**LASELLS STEWART CENTER MECHANICAL & ROOF
RENEWAL**

EXHIBIT I – Alternate Narrative and Alternate Drawings

ALTERNATES NARRATIVE

4 TYP PARAPET AT AUDITORIUM WEST - ALTERNATE NO.6
1 1/2" = 1'-0"

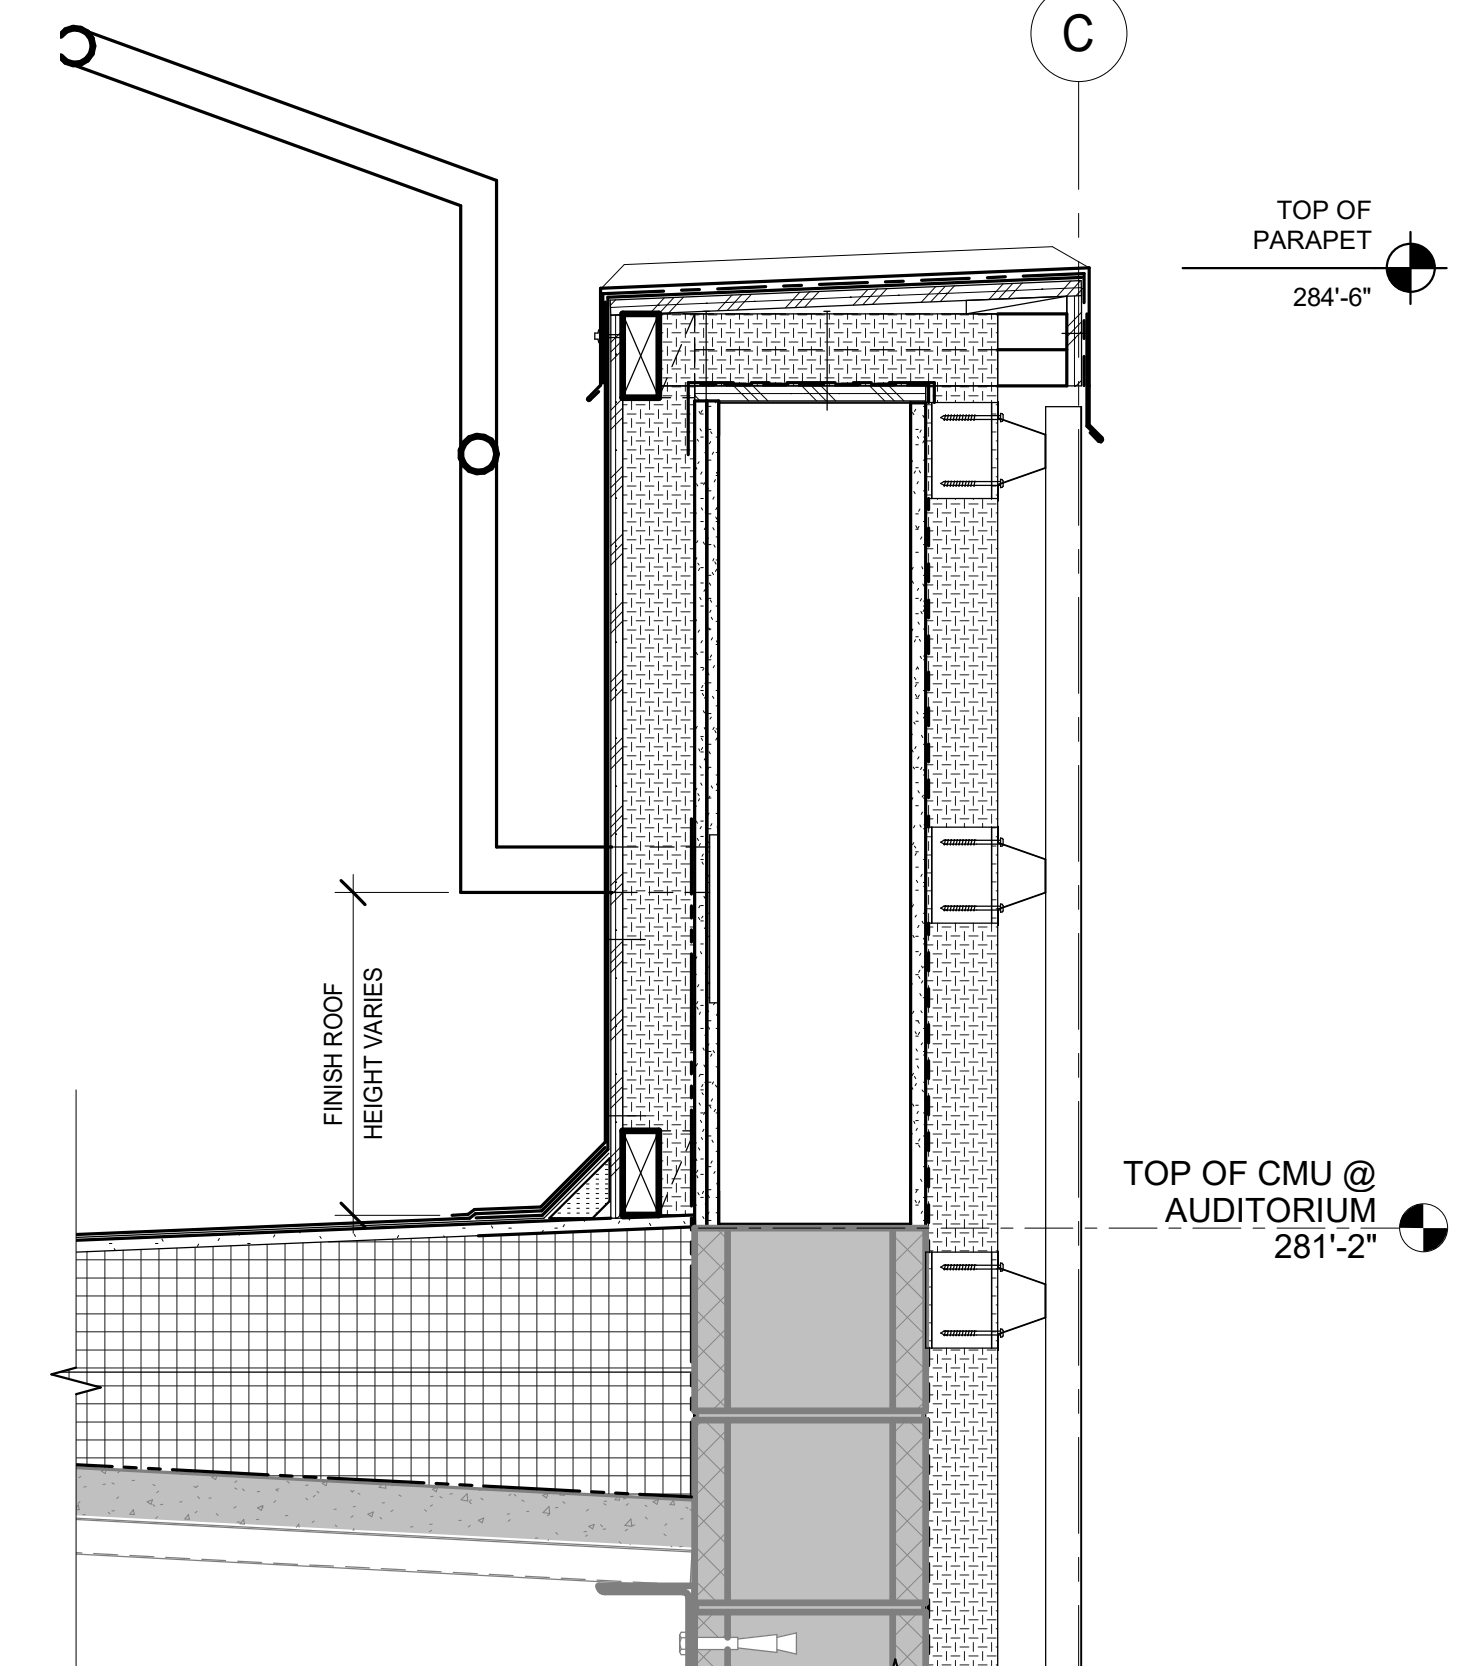
3. Alternate 6: Details 2 and 4/ A5.51A replace Details 1 and 2 A5.52 showing increased height of parapet wall at Auditorium.
 4. Alternate 7: Detail 5/ A5.51A revises parapet height at Stairwell roof.

1 REFLECTED CEILING PLAN - LOWER LEVEL - ALTERNATE NO.3
1" = 10'-0"

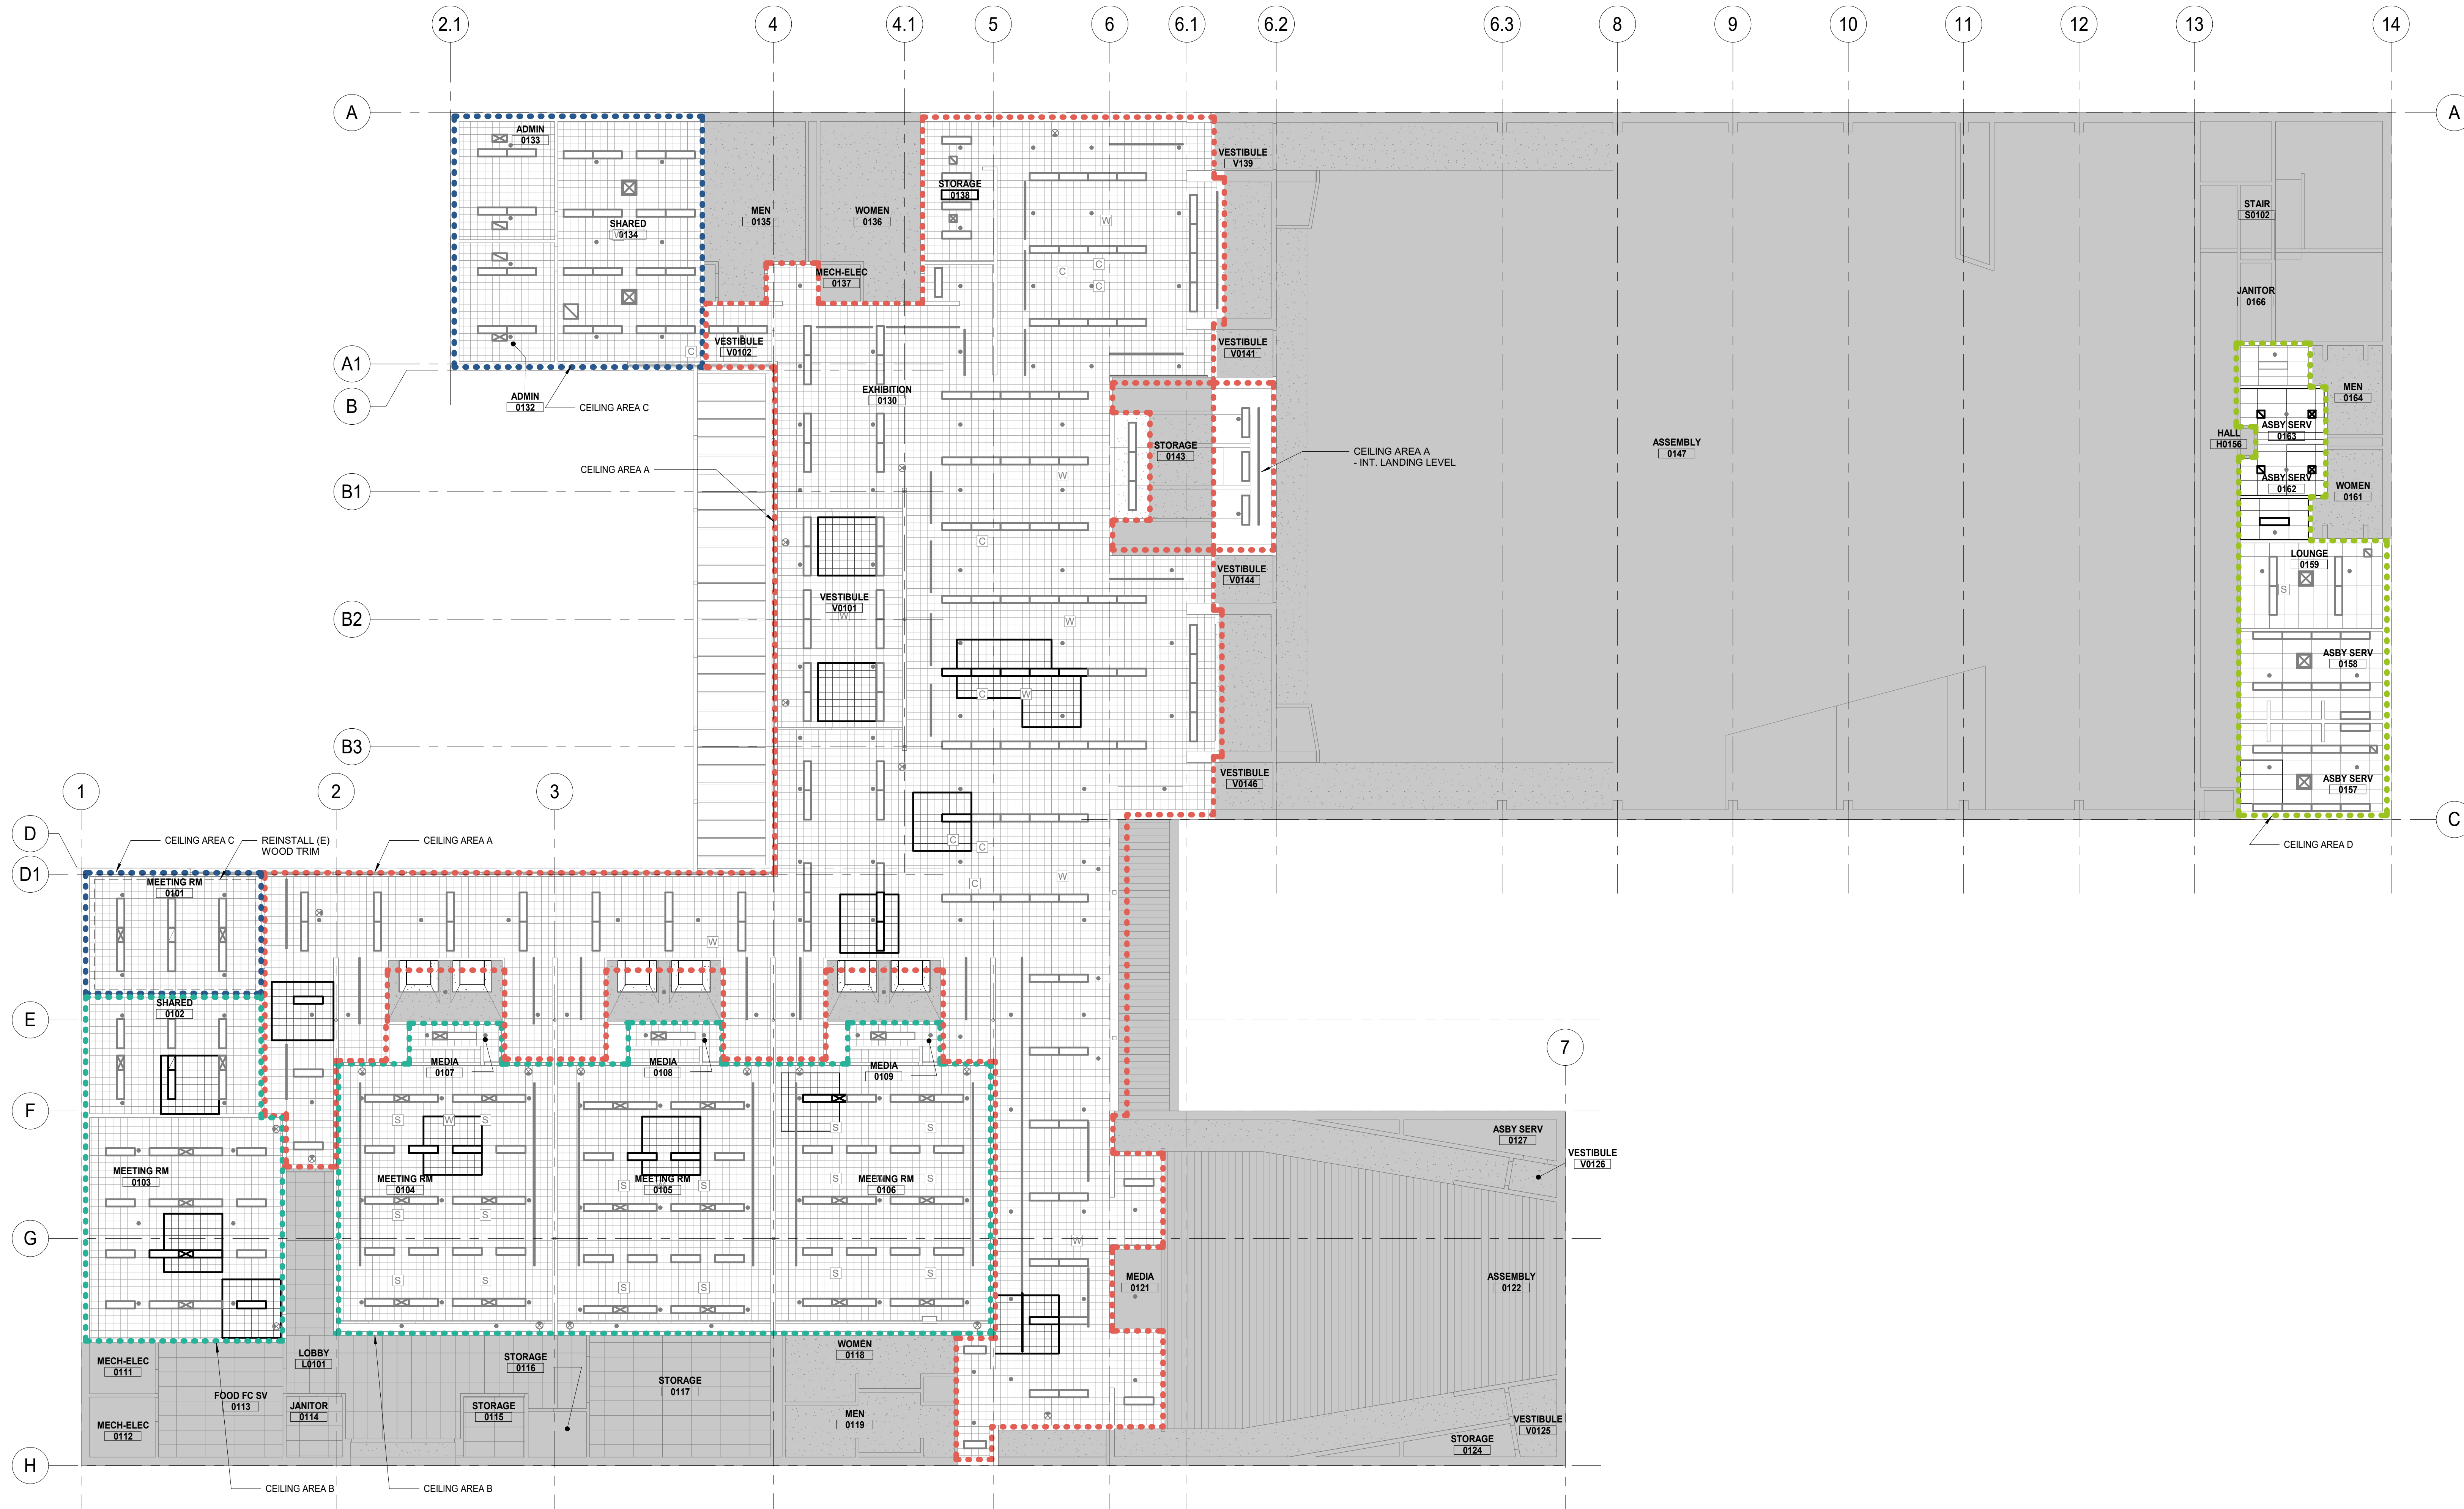
- D. Sheet A8.11A – Reflected Ceiling Plan – Lower Level.
1. Sheet A8.11A – Reflected Ceiling Plan- Lower Level – replaces:
 - a. Detail 1 Sheet AD8.11 – DEMO Reflected Ceiling Plan – Lower Level

- b. Detail 1 Sheet A8.11 – Reflected Ceiling Plan – Lower level.
 2. Alternate 3: Sheet A8.11A indicates limited access areas for remove and replace of equipment above ceilings.

3. Alternates 3A, 3B, 3C and 3D: Sheet A8.11A indicates Work Areas A, B, C and D.
 - a. Sheet A8.11A provides plan of existing ceiling system including, but not limited to lighting, diffusers, and grilles, attached equipment and other systems to remain.
